Access Compliance Report

Public Rights-of-Way

Intersection ID: 45793	Main Street: WINDING_RIVER_DR	Cross Street: GRANITE_TRAIL_LN	Location: NW
ADA ID: CFDCFA279B99	Ramp Type: BlendTrans1	Initial Pass/Fail: Fail	Overall Compliance: No
		Severity Score: 10

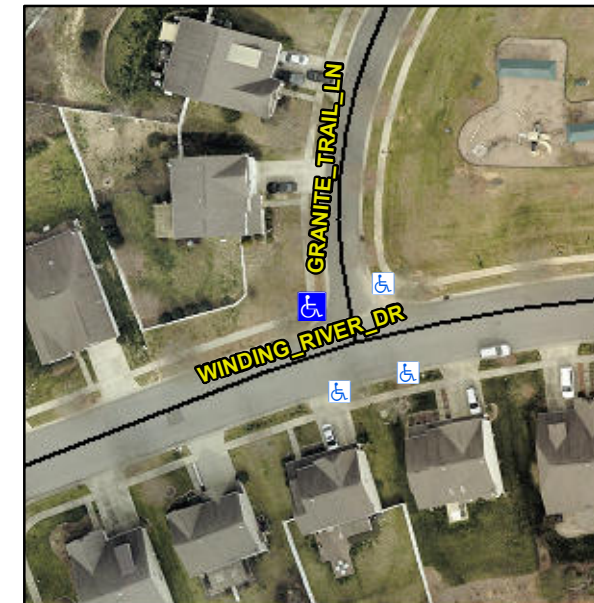
Not Found, R304.5.1, R304.5.3

Compliance	Description	Data	Compliance	Description	Data
N/A	Ramp Length (in)	74.0	Yes	BlendTrans Slope (%)	2.3
No	Ramp Width (in)	47.5	No	BlendTrans XSlope (%)	3.7
N/A	Flare Type LT	N/A	N/A	Flare Type RT	N/A
N/A	Flare Slope LT (%)	N/A	N/A	Flare Slope RT (%)	N/A
N/A	Flare Traversable LT?	N/A	N/A	Flare Traversable RT?	N/A
N/A	Landing Length (in)	N/A	N/A	DWS Provided?	N/A
N/A	Landing Width (in)	N/A	N/A	DWS Contrast?	N/A
N/A	Landing Slope (%)	N/A	N/A	DWS Length (in)	N/A
N/A	Landing X Slope (%)	N/A	N/A	DWS Full Width?	N/A
N/A	Landing Curb? (Y/N)	N/A	N/A	DWS Offset (in)	N/A
N/A	Shared Landing?	N/A			
N/A	Gutter Ponding?	N/A	N/A	Gutter Slope (%)	N/A
N/A	Gutter Lip Ht (in)	N/A	N/A	Gutter X Slope (%)	N/A
N/A	Painted X Walk1?	No	N/A	Painted X Walk2?	No
	X Walk 1 Direction	To S		X Walk 2 Direction	To E
	X Walk 1 Width (in)	N/A		X Walk 2 Width (in)	N/A
	X Walk 1 Slope (%)	0.0		X Walk 2 Slope (%)	1.7
	X Walk 1 X Slope (%)	3.8		X Walk 2 X Slope (%)	3.4

Remove & Replace Curb Ramp With Two New Directional Ramps or Equivalent.
